Letter Number: AVC-14-005

Subject: 10 CFR Part 21 Report Notification, NUS710DU Trip Units

NUS-710DU0TT; A Master Trip Unit manufactured by Scientech.
NUS-710DU0TS; A Slave Trip Unit manufactured by Scientech.

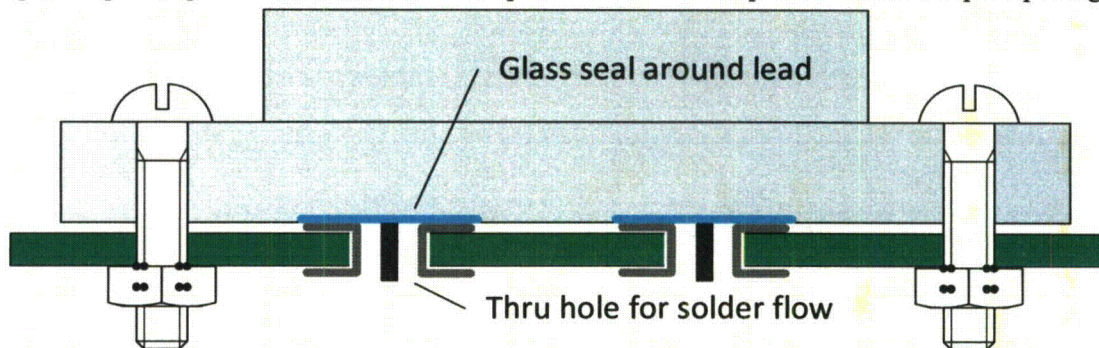
In certain operating configurations, NUS-710DU Trip Units could fail to produce a valid trip output signal.

Transistor Q8 on the referenced units uses a TO-66 package and is flush mounted on the component side of the PCB. The TO-66 package, based on JDEC drawing TO-213 does not specify the size of the glass-sealed holes in the case (collector) around the base and emitter leads. Random samples measure approximately 0.11" in diameter. The PCB includes standard 0.100" solder pads on both non-component and component sides. During manufacture, Q8 is secured using screws and nuts with leads centered in the through-holes, so no direct solder pad to case contact is possible. However, the presence of the pad on the component side could facilitate, under certain conditions, excessive solder flow, creating a close proximity, or in the extreme case bridging, between solder on the emitter or base solder pad and the Q8 case. Permanent bridging would be detected during acceptance testing. However, in at least one case, with the trip unit mounted in the trip unit chassis via an extender card, the proximity was close enough to create contact when the board was slightly flexed.

In configurations (1) and (2), bridging at Q8 would cause an output trip signal.

In configurations (3) and (4), bridging at Q8 would prevent a valid trip signal from being generated by keeping the output at logic high.

1. Scientech has identified a design change that corrects the problem. The correction is to install spacers under Q8 to provide clearance from the board. The Design Change Notice was complete May 7, 2014.
2. Scientech has placed a hold on all affected in-house modules, and will incorporate the design change prior to ship.
3. Scientech will notify the plants listed per 21.21(d)(4)(vi) above, and offer to correct the affected units at Scientech's facility by close of business May 8, 2014.
